# INSPECTION OF MECHANICAL FEATURES

## Helmand Valley
## Development Project

Prepared for Agency for International Development

May 1964

Drawing No. 9

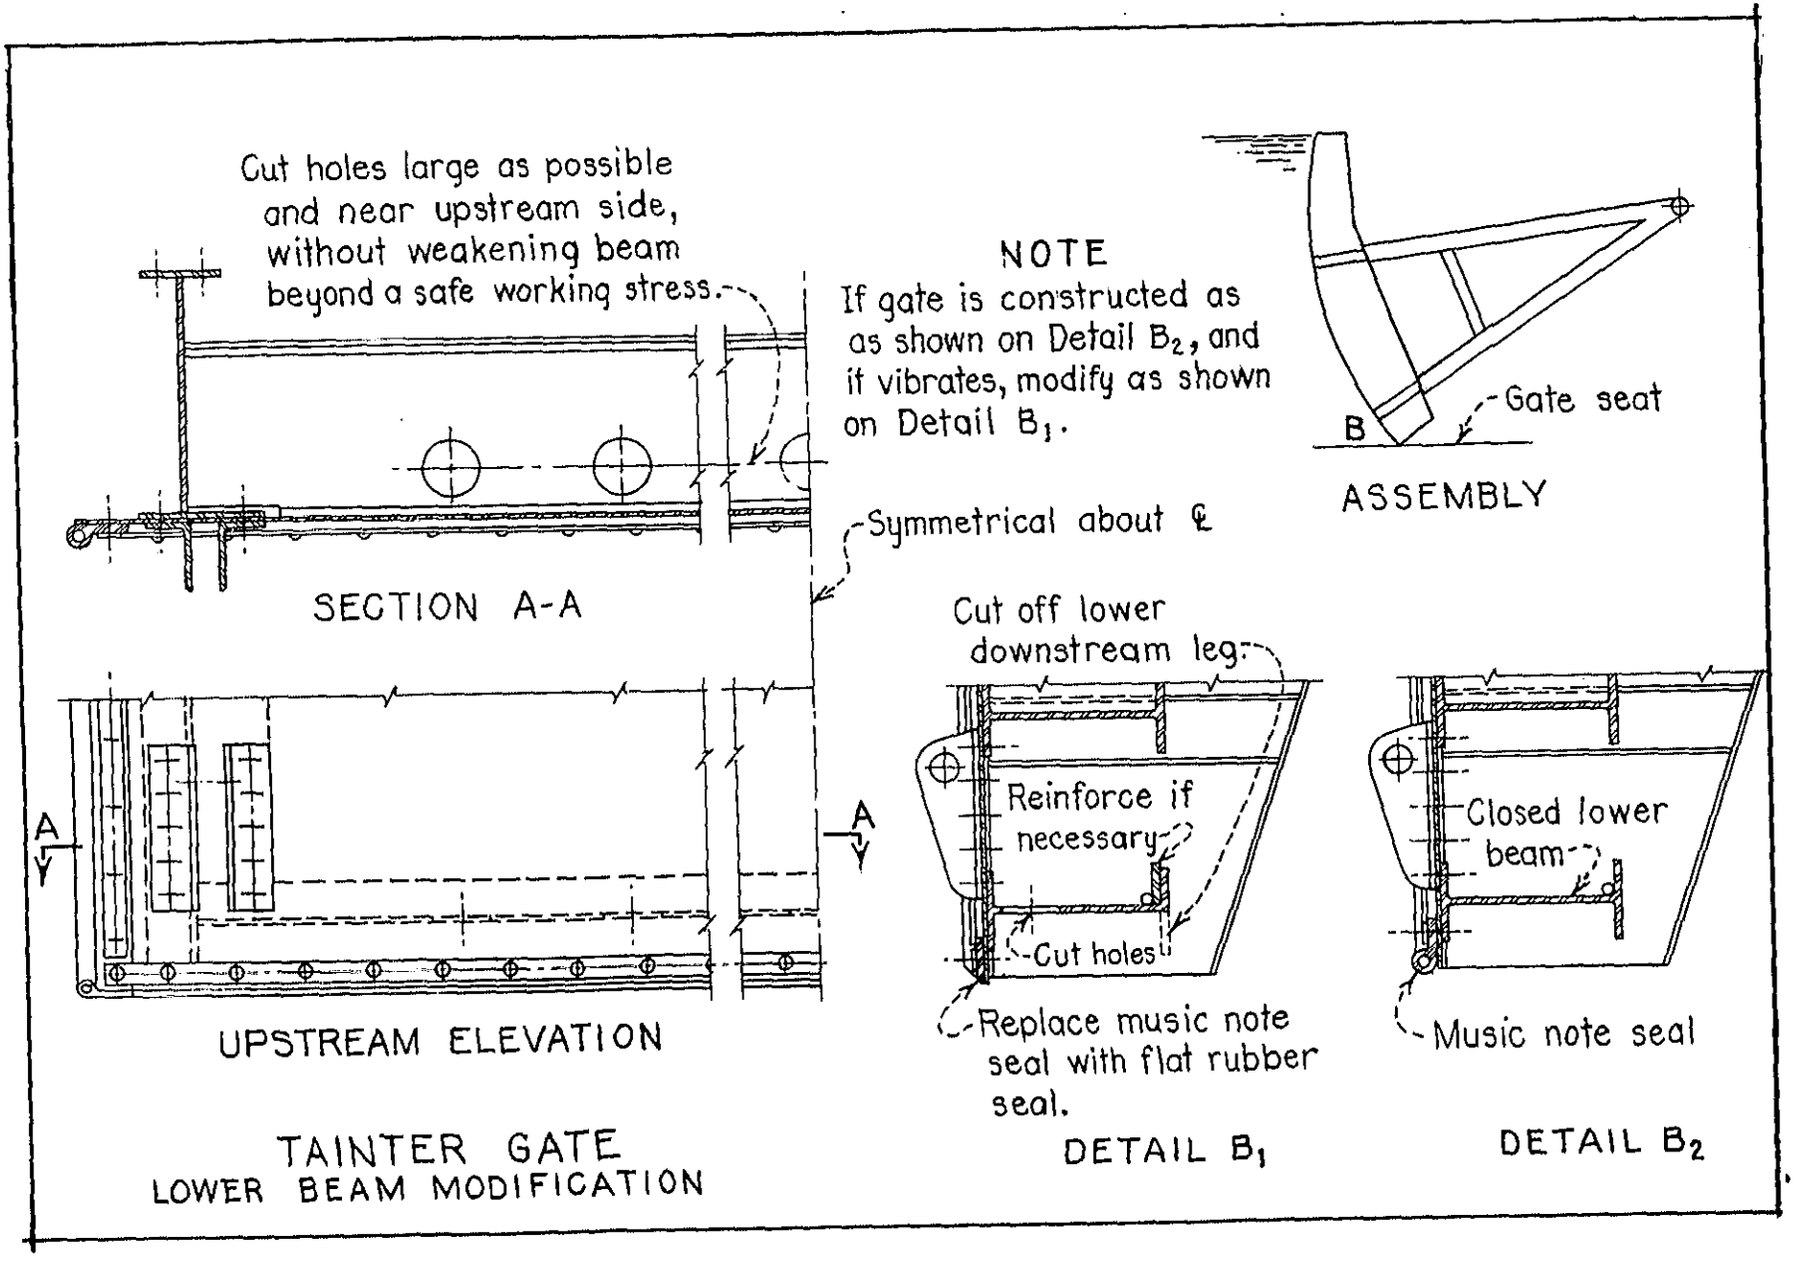
2. Vibration of tainter gates results from fluctuating pressures under the bottom seals and beams when the tailwater is above the lower beam. Fluctuating pressures can result when music note seals or closed beams are used across the bottom of the gate as shown in Detail B2, Drawing No. 9.

Vibration may be minimized or eliminated by replacing the music note seals with a flat rubber seal, by cutting holes through the web of the lower beam, and by cutting off the lower half of the downstream flange of the bottom beam. See Detail B1, Drawing No. 9, noting flange reinforcement.
